Planning Commission Study Session

MEETING DATE: NOVEMBER 1, 2023

SUBJECT: DR23-88, FAST MARKET GAS STATION

DR23-88 FAST MARKET: Site plan, landscaping, grading and drainage, elevations, floor plans, lighting, and colors and materials for approximately 2.94 acres, generally located at the southeast corner of Val Vista Drive and Queen Creek Road and zoned Shopping Center (SC) with a Planned Area Development (PAD) overlay.

Drawn Checked SJS
07/14/2023 HDR
Project No. Title
Sheet No. **C-1**

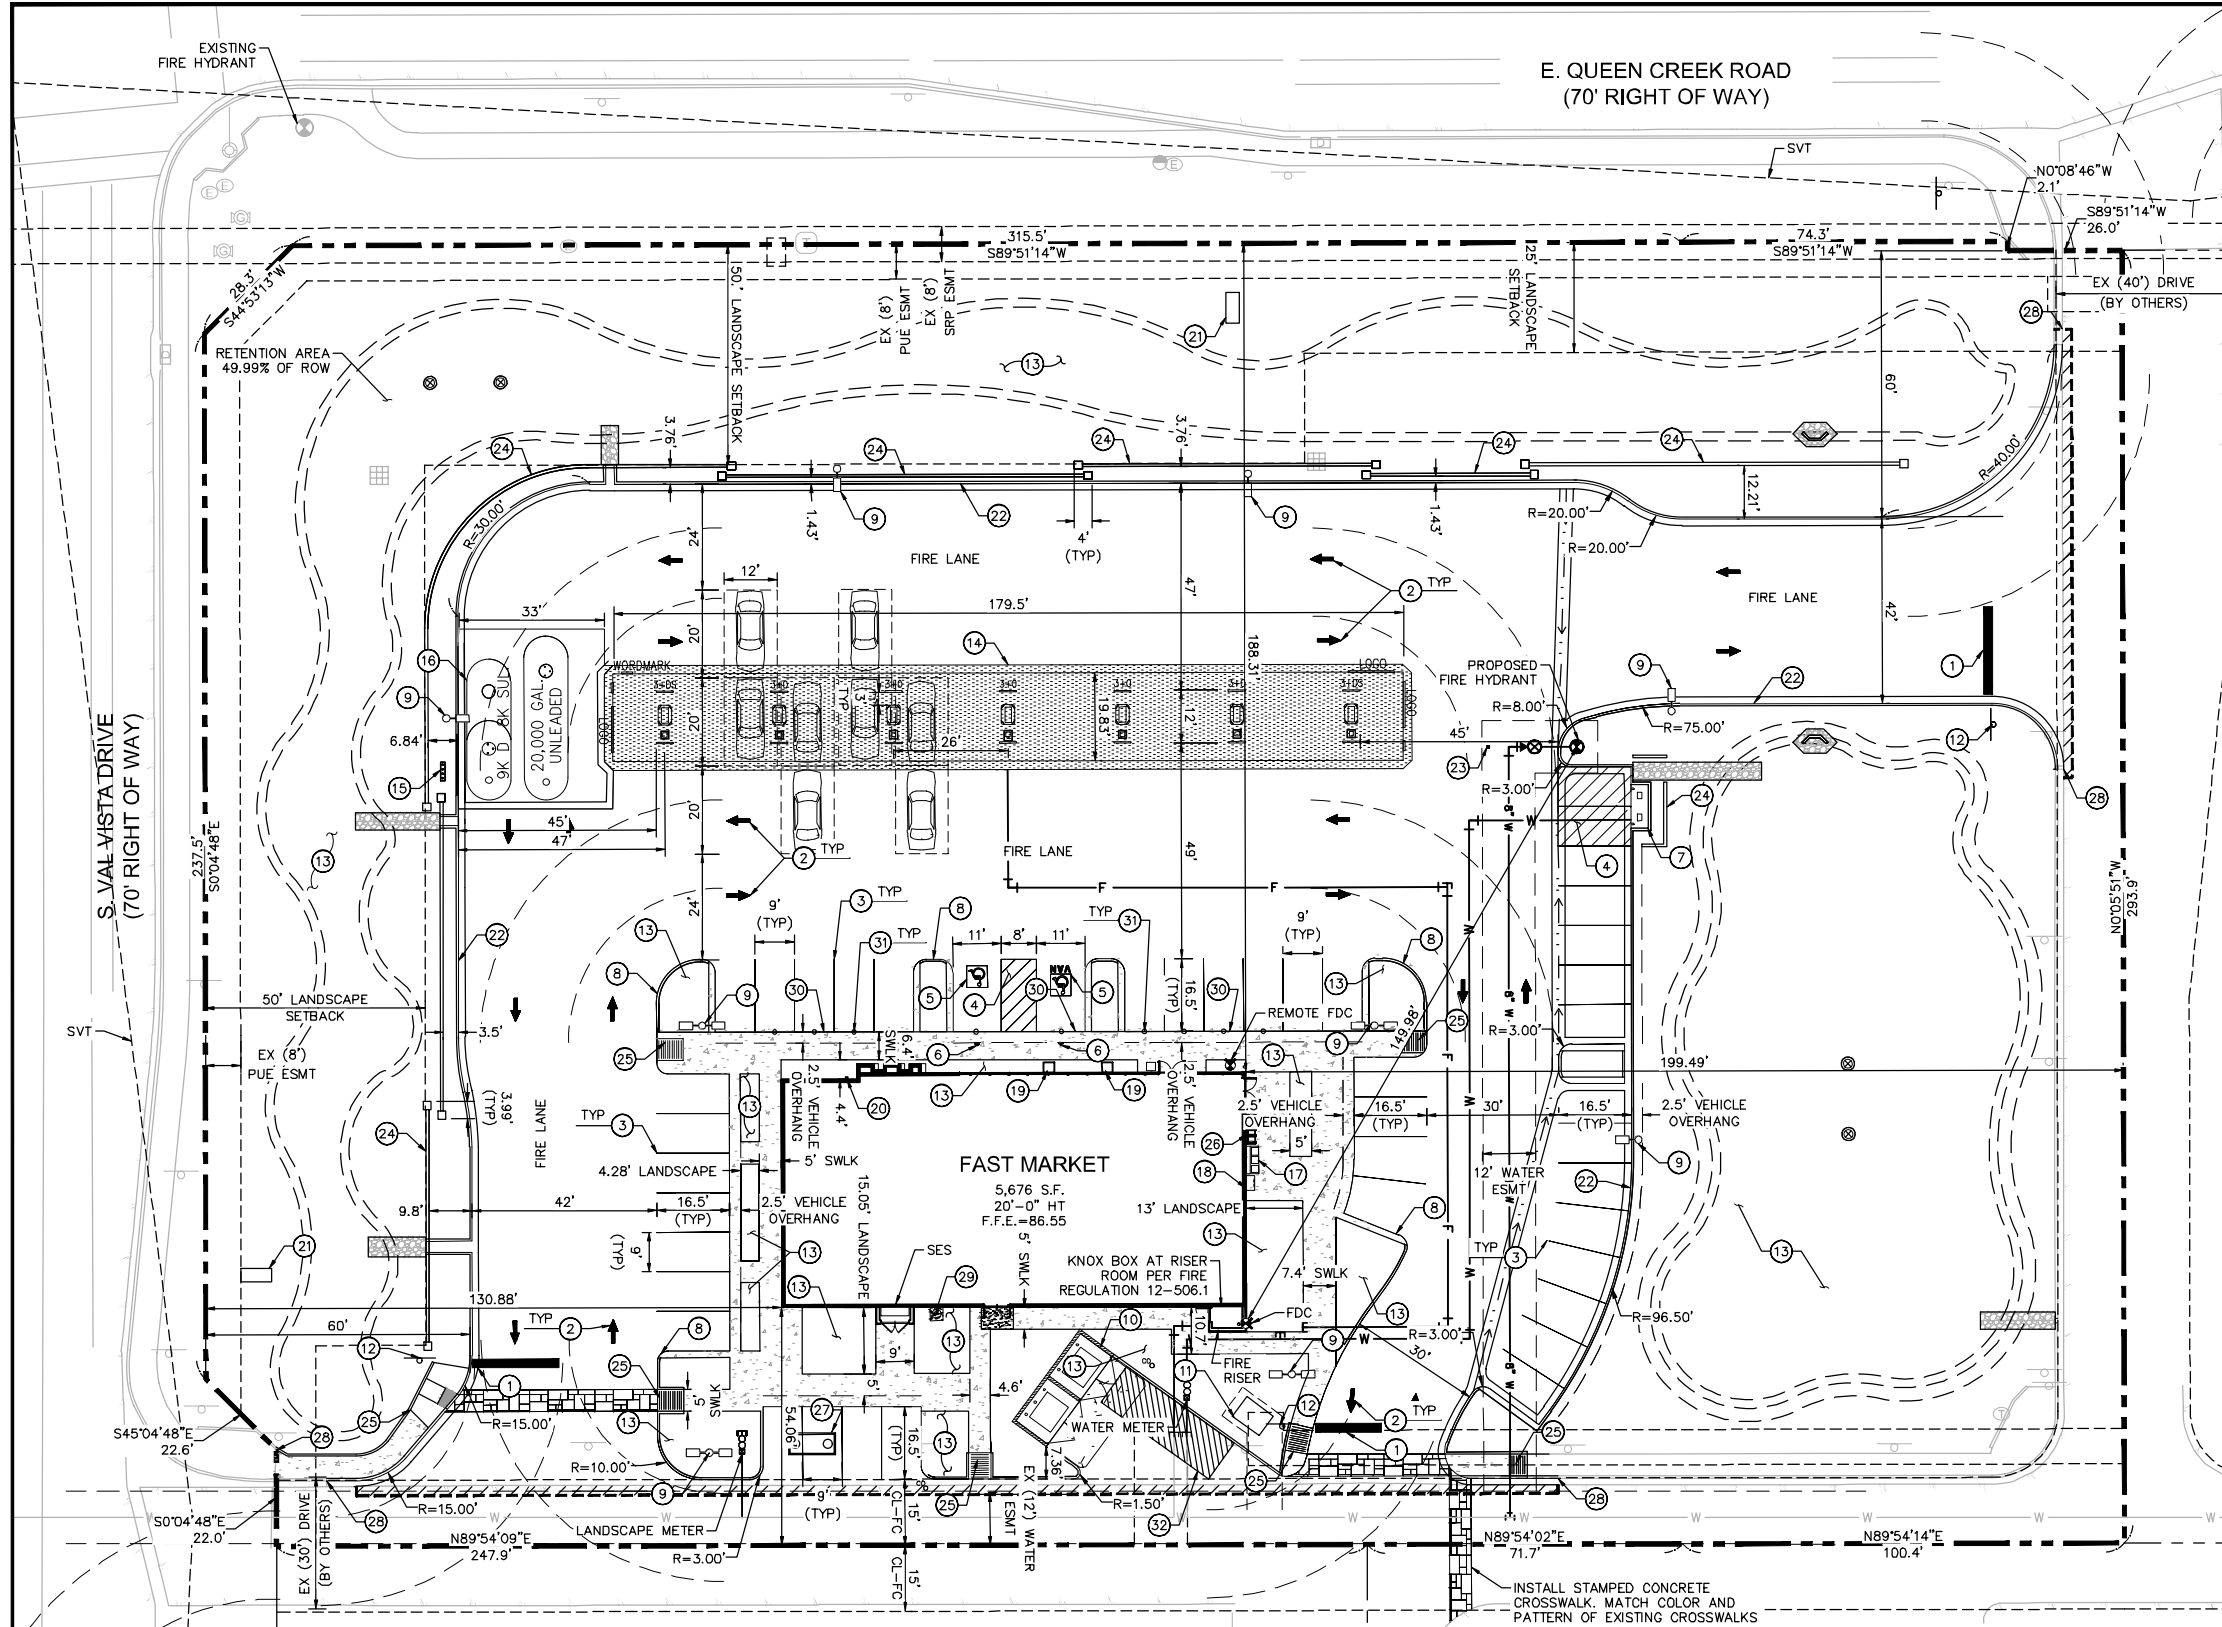
The proposed Fast Market Gas station has continued the existing landscape palette and extended pedestrian and vehicular circulation onto the site. Parking surrounds the convenience store building; however, staff has requested that the applicant consider the removal of the parking spaces on the south side of the building along the main drive aisle. 57 parking spaces are provided where 23 are required, and removal of these spaces will reduce conflict with the primary access aisle through the master site.

GRADING & DRAINAGE PLAN

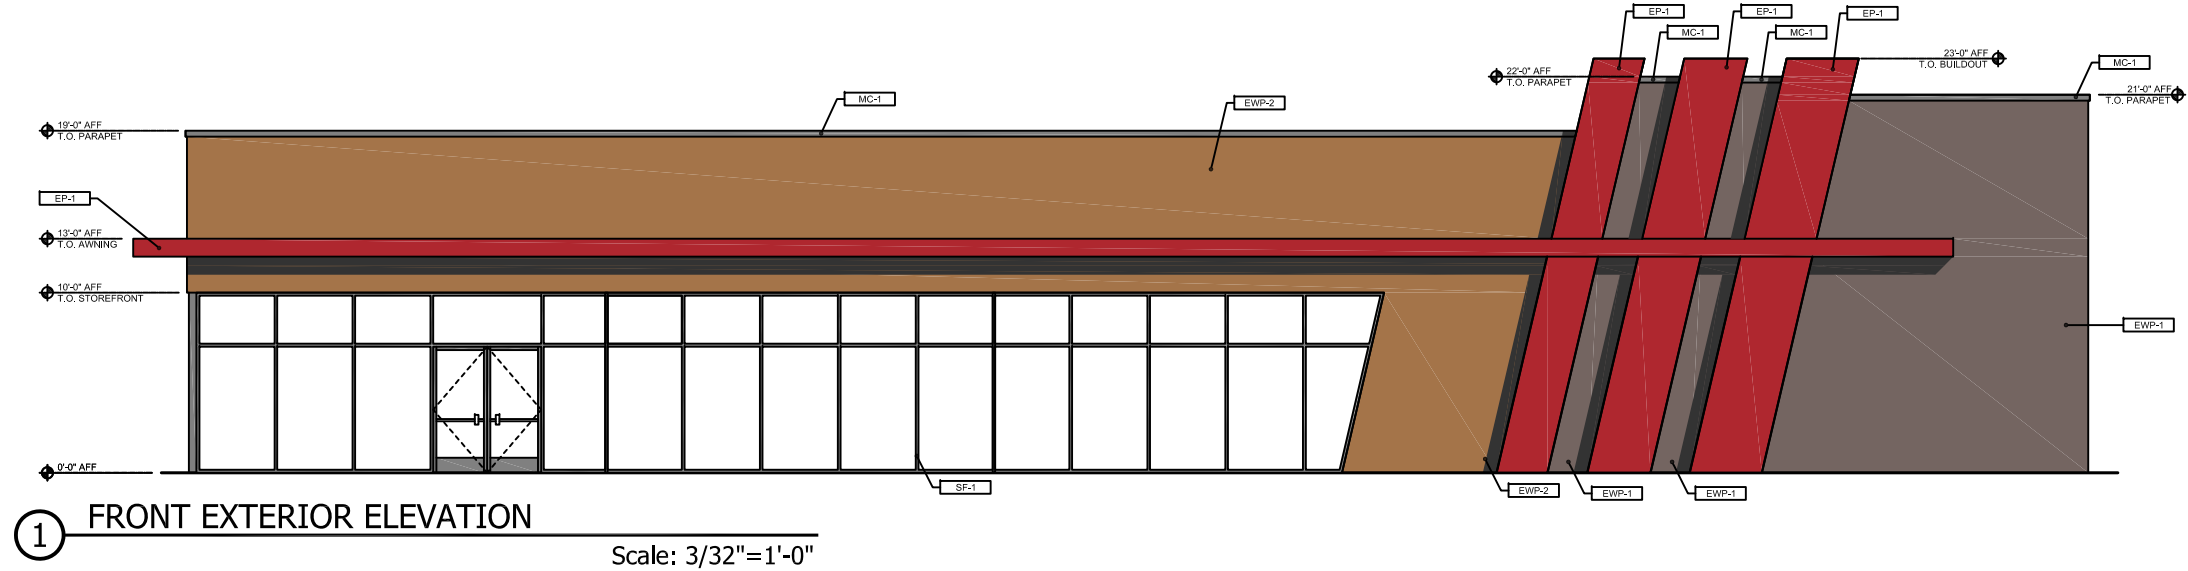
The on-site retention is proposed in the form of above-ground retention basins in the street frontage landscape area and an open space area to the east of the Fast Market Building. The proposed grading and drainage plan will generally meet the requirements of the Town of Gilbert's Engineering Division once all first review engineering comments are addressed.

Project No.	4634	Date	10/10/2023
Scale	AS NOTED	Project Mgr.	MButler
Sheet	A400

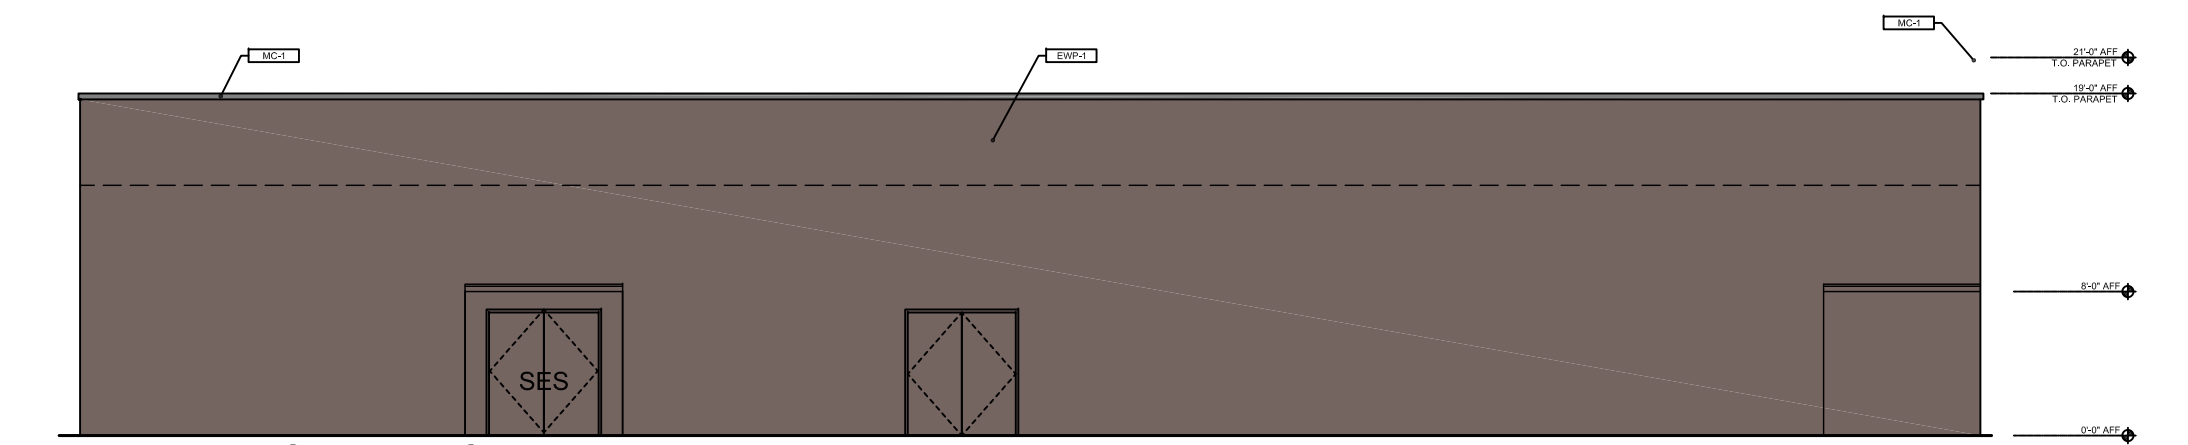
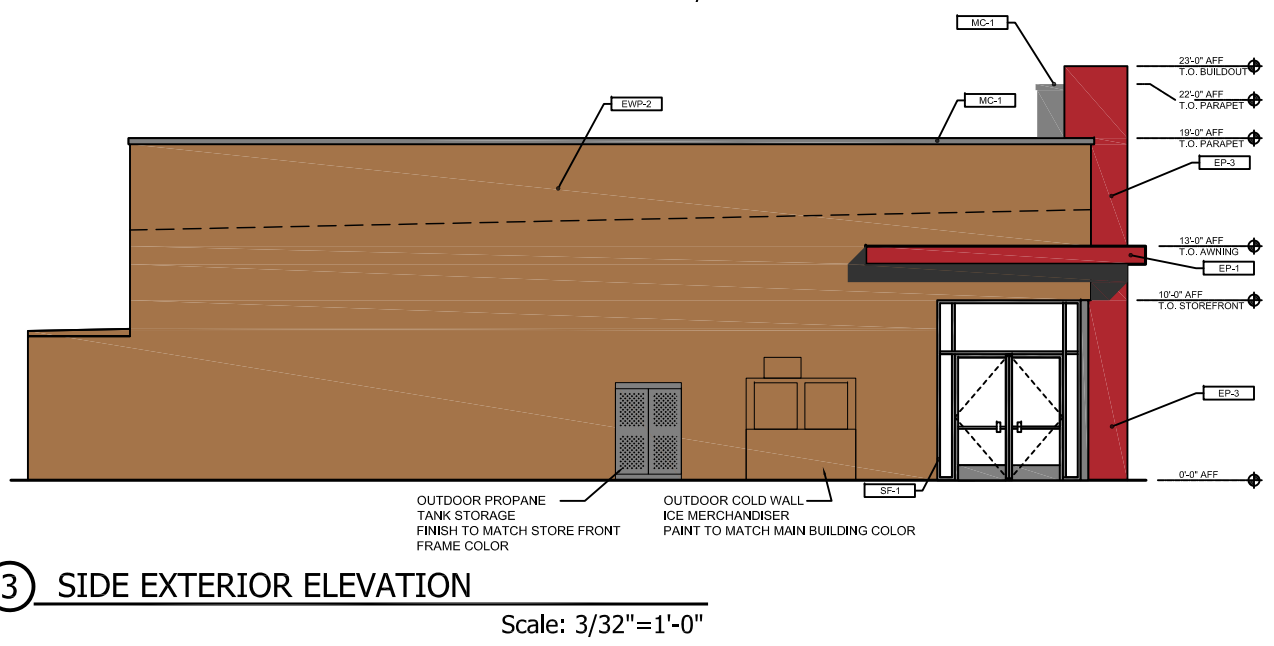
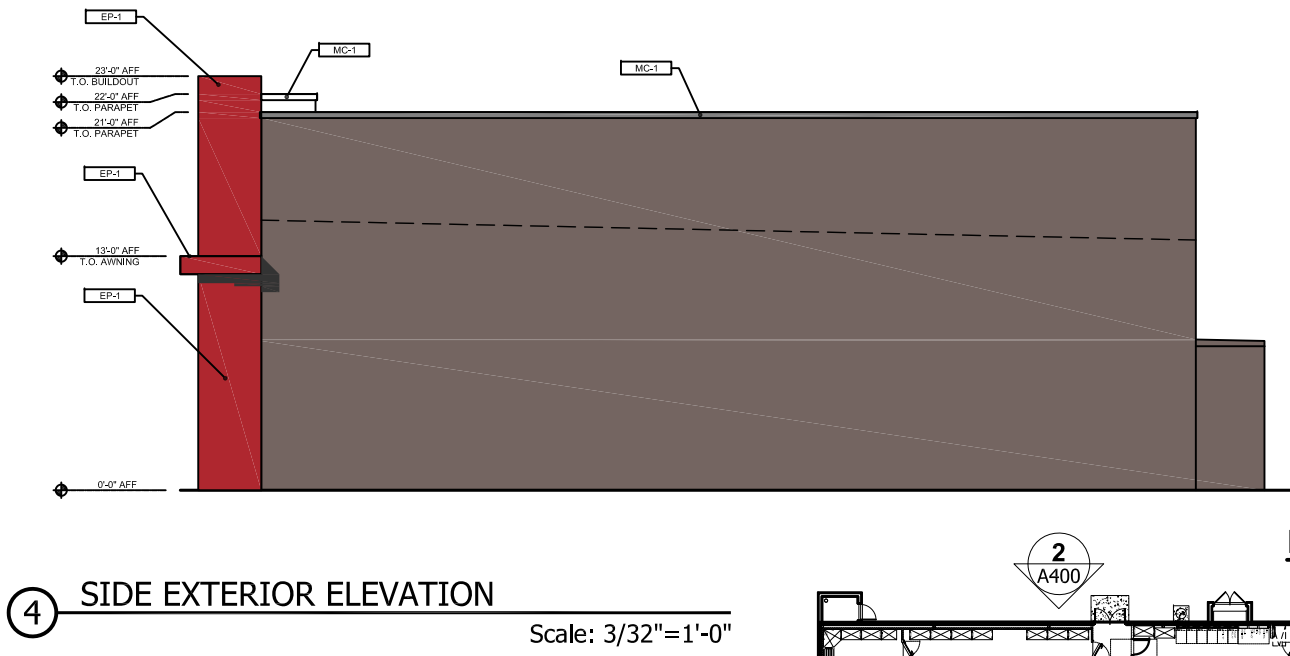
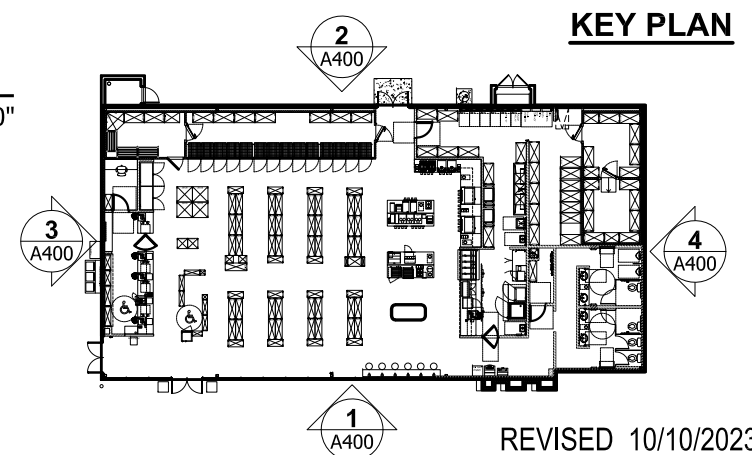
The fueling facility includes seven (7) fuel bays with fourteen (14) fuel pumps under a covered canopy and is approximately 180' long, 20' wide, and 17' high. The canopy itself is proposed to be painted to match the building and provides no variation in the canopy itself in colors, materials, or articulation. Staff is requesting revisions to the canopy to better align with Town of Gilbert design guidelines for architectural integration and high-quality design.

There is one (1) building proposed for the site that is approximately 23' in height to the tallest point. The primary building material is Nichiha Tuffblock and Nichiha Fiber Cement Paneling. Along the front, variations in red are used as an accent along with expansive storefront windows. Staff is requesting variation in materials along the rear and side elevations to create additional visual interest as these sides of the building do not have sufficient material or building movement. Staff notes that the rear elevation is highly visible from a primary access drive through the site.

Additionally, staff seeks Planning Commission feedback on whether or not a cultured stone wainscoting around the perimeter base of the building would benefit the overall design. Cultured stone wainscoting can be seen throughout the center and could potentially provide some continuity across the center.

1. Building and Fuel Canopy Elevations
